Implementation experience with UN-R160 – Proposal for Step 2

Tokyo, April 10th 2024

EDR EXPERIENCES WITH UN-R160

Time zero, recording trigger and locking trigger of VRU Events

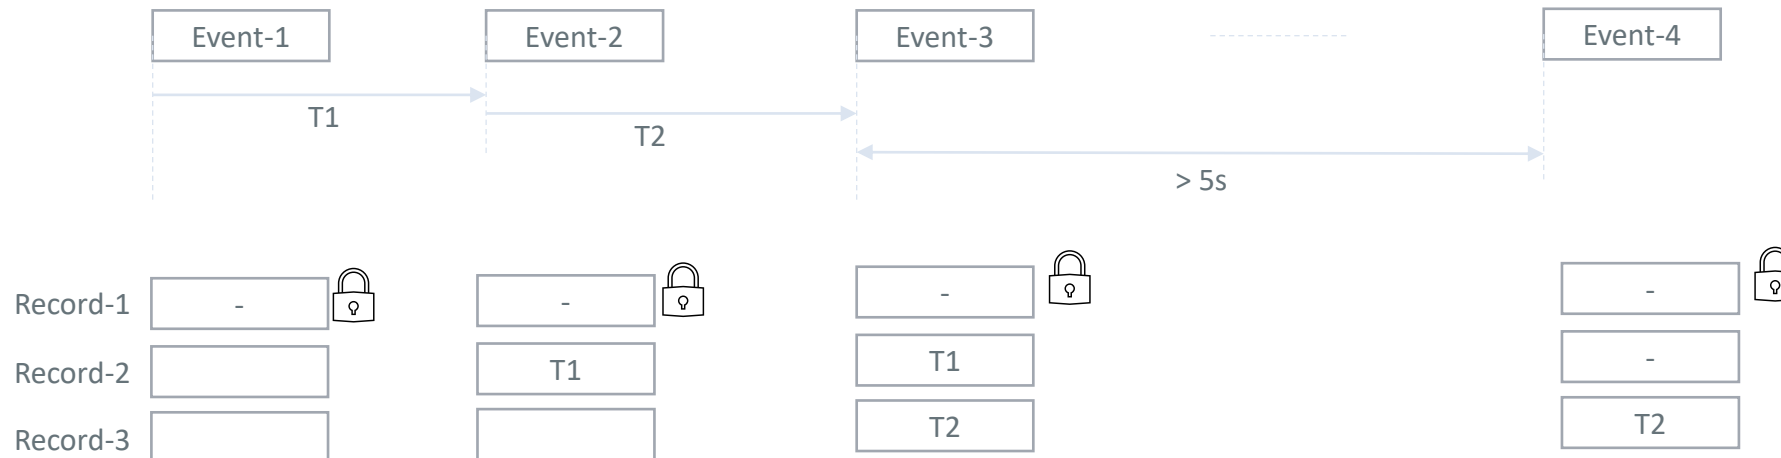
For systems with “wake-up” airbag control systems, Time zero and recording/locking trigger provisions of VRU Events are inconsistent with that of Other Events.

Time zero condition at [5.3.3.1] states For systems with "wake-up" air bag control systems, the time at which the occupant restraint control algorithm is activated.

This excludes possibility to apply similar condition to VRU Events, even if VRU secondary safety control system is also “wake-up” type.

Time from event 1 to 2

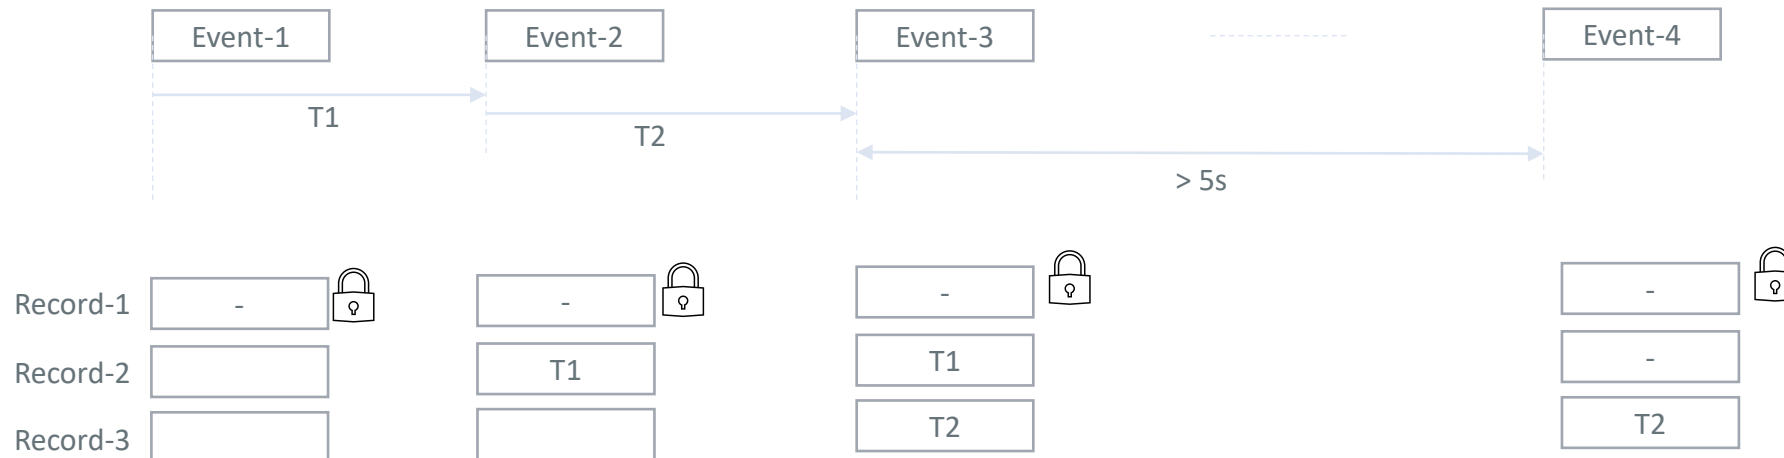
Definition: means the elapsed time from time zero of the first event to time zero of the second event of a multi-event crash.

1. This definition falls short in multi-Event crash with more than 2 Events.
2. If some of Event(s) from multi-Event crash are overwritten by subsequent Events, then time relation between recorded Events is lost

- There is no reference Event for T2
- There is no relative time between Events in 3 records
